**METROPOLITAN GOVERNMENT OF NASHVILLE AND DAVIDSON COUNTY**

**STAFF RECOMMENDATION**  
**1818 Fifth Avenue North**  
**February 19, 2014**

**Application:** New construction-infill  
**District:** Salemtown Neighborhood Conservation Zoning Overlay  
**Council District:** 19  
**Map and Parcel Number:** 08108027300  
**Applicant:** Robin York; R. J. York Homes, LLC  
**Project Lead:** Sean Alexander, sean.alexander@nashville.gov

<p><b>Description of Project:</b> The applicant proposes to construct a new two-family dwelling on a vacant lot.</p> <p><b>Recommendation Summary:</b> Staff recommends approval of the duplex infill and outbuilding with the following conditions:</p> <ul style="list-style-type: none"><li>• That the roof and eaves of the front porch be raised to make the perceived height of the first story taller in relation to the upperstory;</li><li>• That the thickness of the porch floor and porch rack be increased to a size more compatible with nearby historic houses;</li><li>• Staff review and approve the roof color and the materials for the trim, as well as the porch columns, porch floor, and foundation;</li><li>• Staff review and approve all window and door selections

Scale 1" = 20'

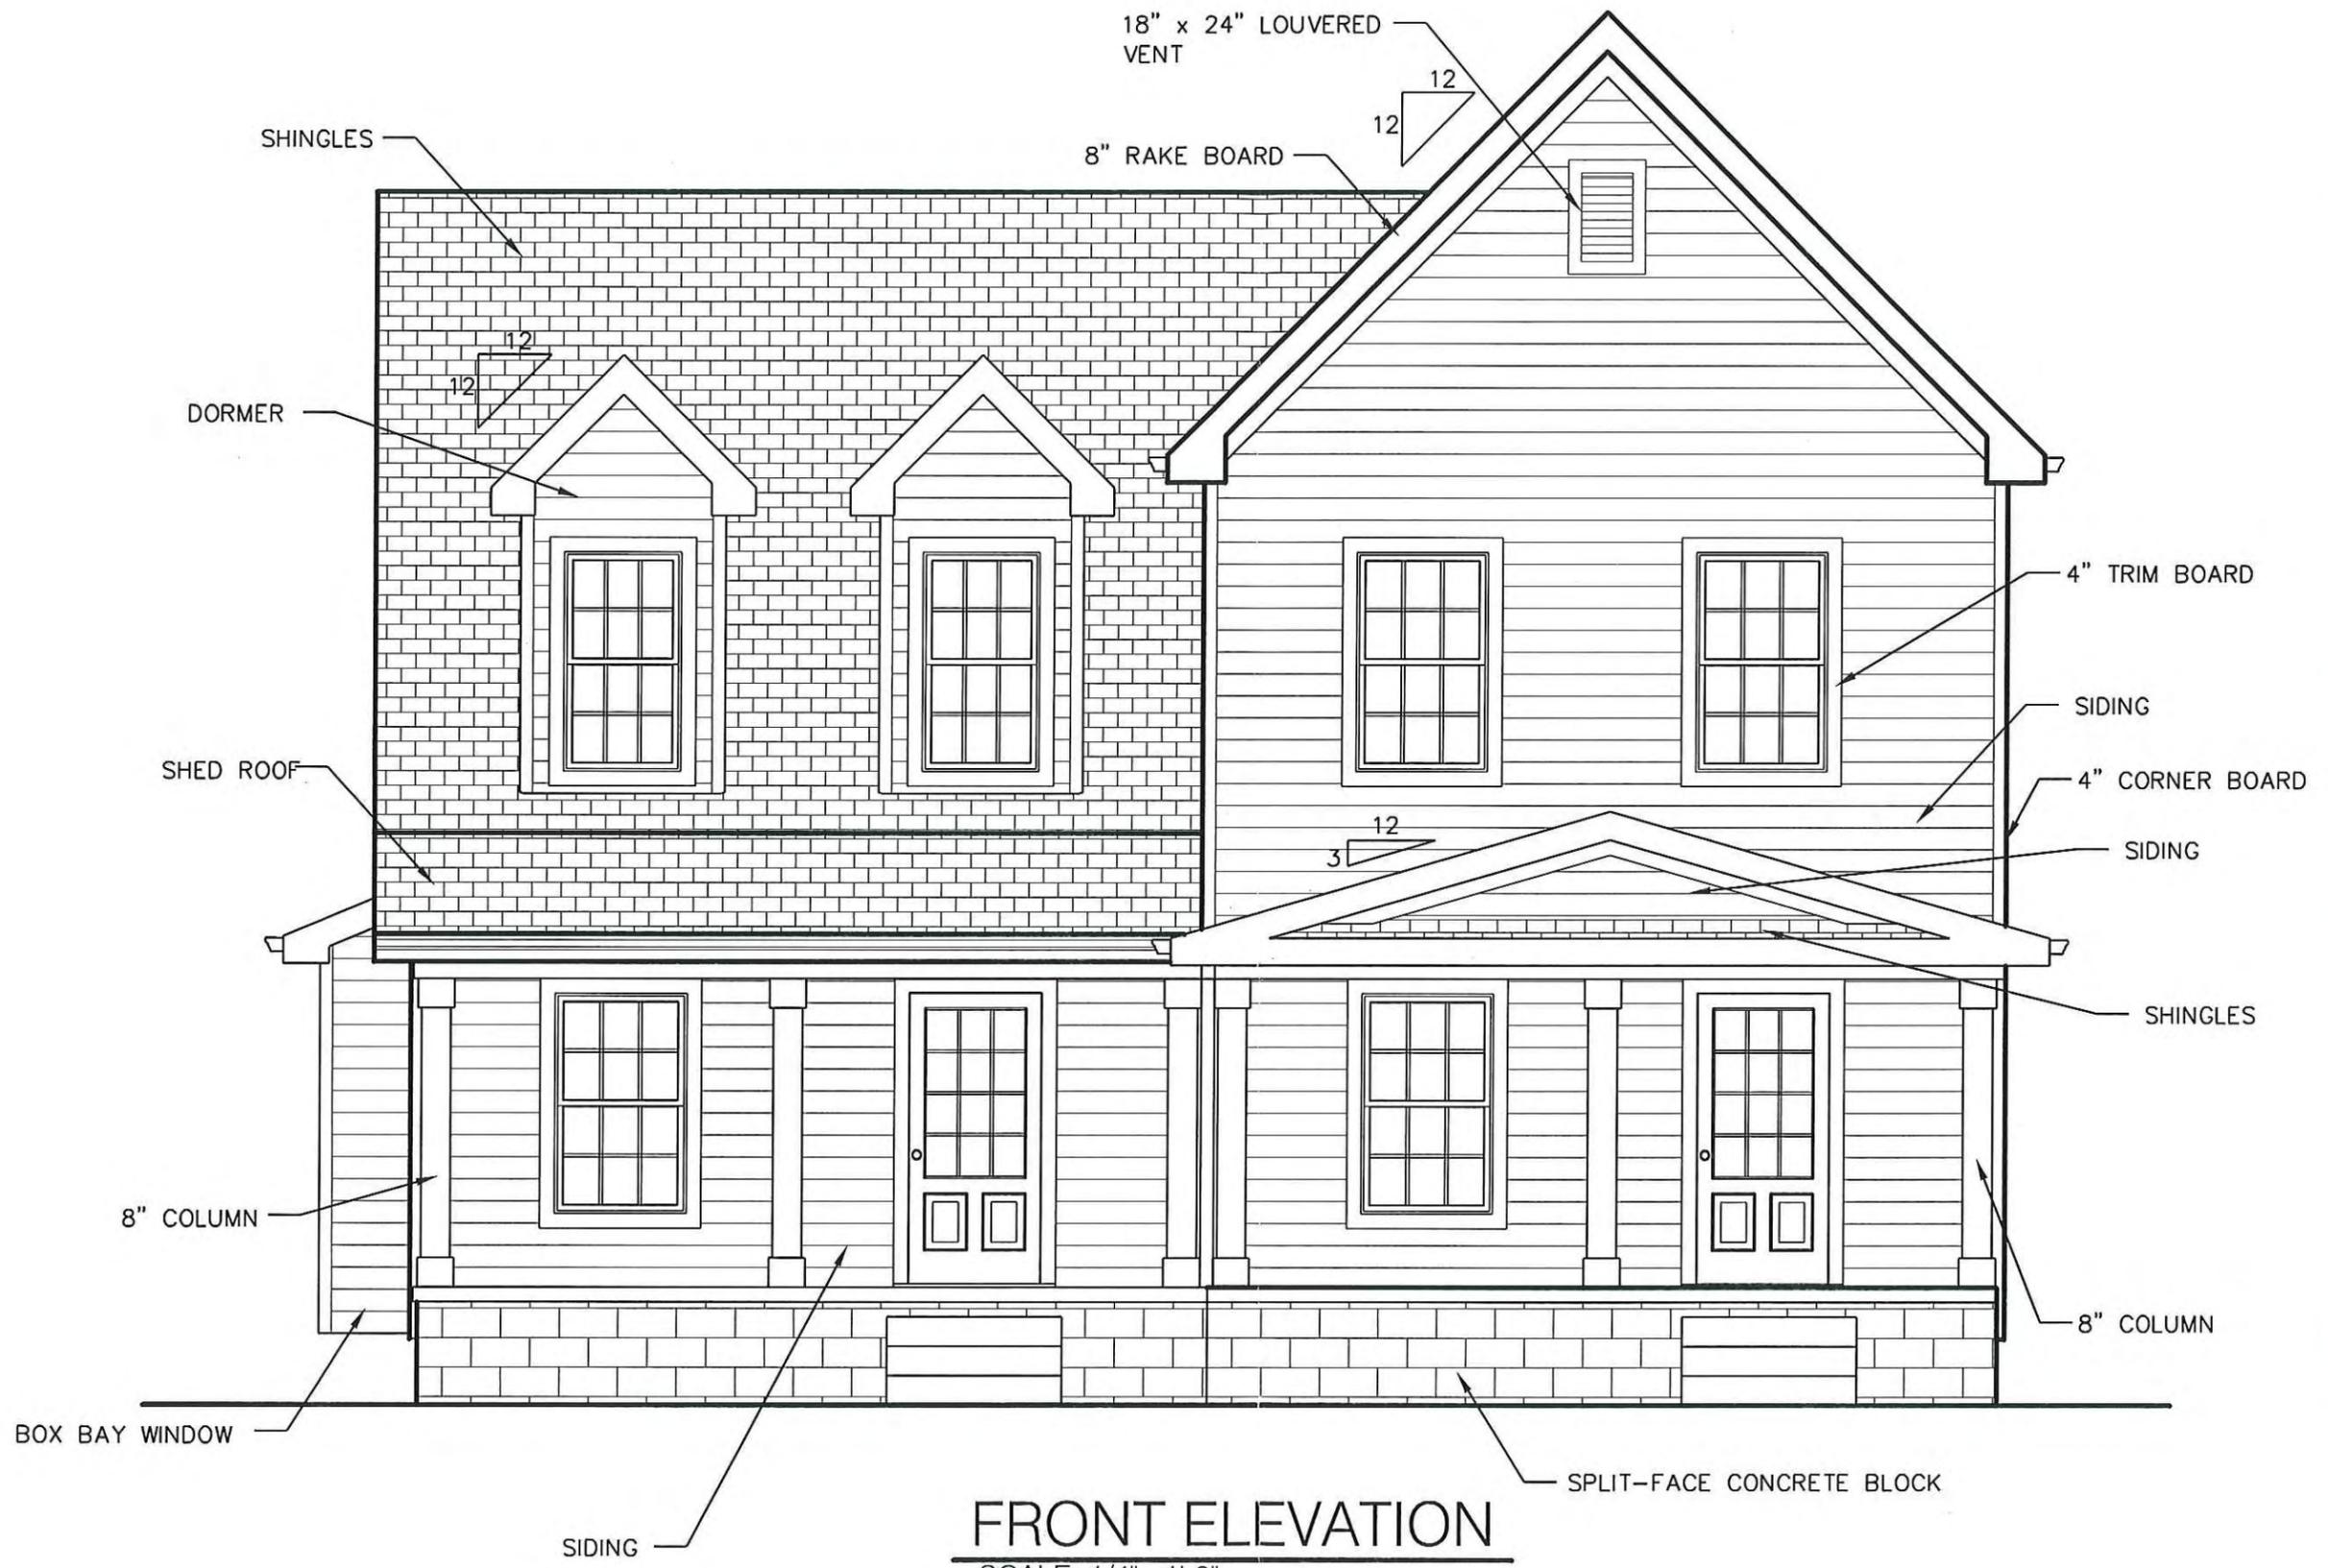
The proposed infill will be centered on the lot and will meet all base zoning setback requirements. The structure will be seven feet (7') from each of the side property lines, creating similar spacing between it and adjacent structures as is found in the historic context and maintaining the established rhythm of the street.

The front porch on the right side will be twenty-six feet (26') from the front property line. This setback is in between the two nearest historic structures, the setbacks of which are twenty-one feet (21') and thirty-two feet (32'). Staff finds that the duplex's setbacks are

The site plan shows a detached garage at the rear of the lot, but no other plans for it have been submitted for review at this time.

**FRONT ELEVATION**  
 SCALE: 1/4" = 1'-0"

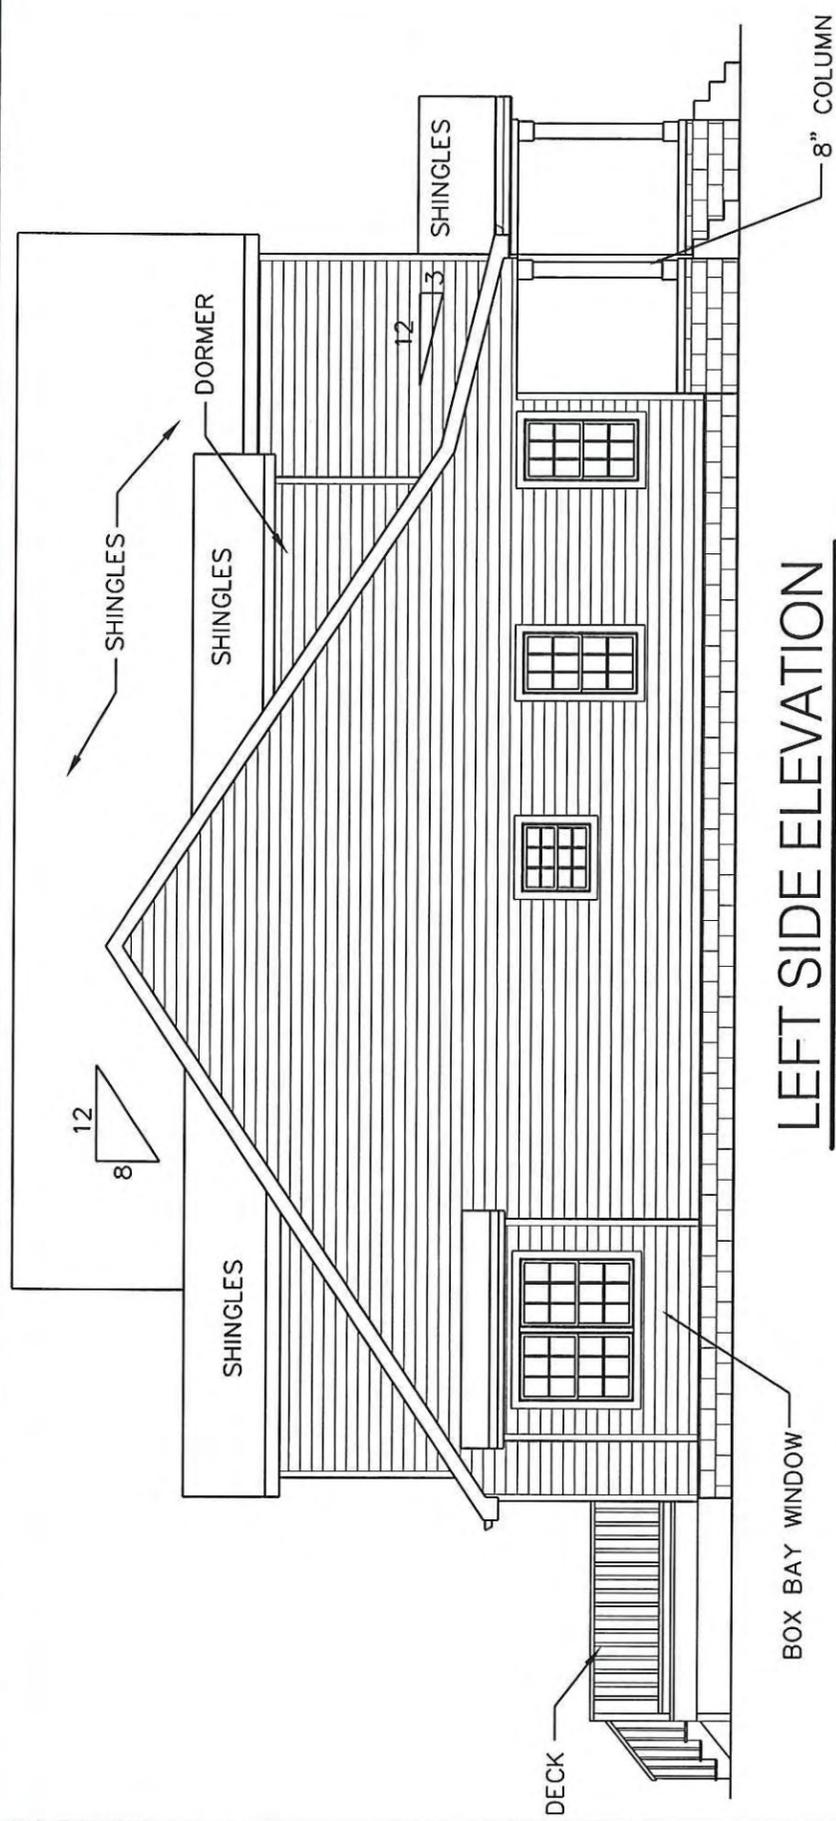
Staff finds the thickness of the porch floor and porch rack to be inappropriately small compared to similar elements on historic houses, and recommends that they be increased proportionally as a condition of approval.

- That the roof and eaves of the front porch be raised to make the perceived height of the first story taller, in relation to the upperstory;
- That the thickness of the porch floor and porch rack be increased to a size more compatible with nearby historic houses;
- Staff review and approve the roof color and the materials for the trim, as well as the porch columns, porch floor, and foundation;
- Staff review and approve all window and door selections prior to purchase and installation;
- The HVAC unit be placed at the rear, or on a side façade beyond the midpoint of the house.
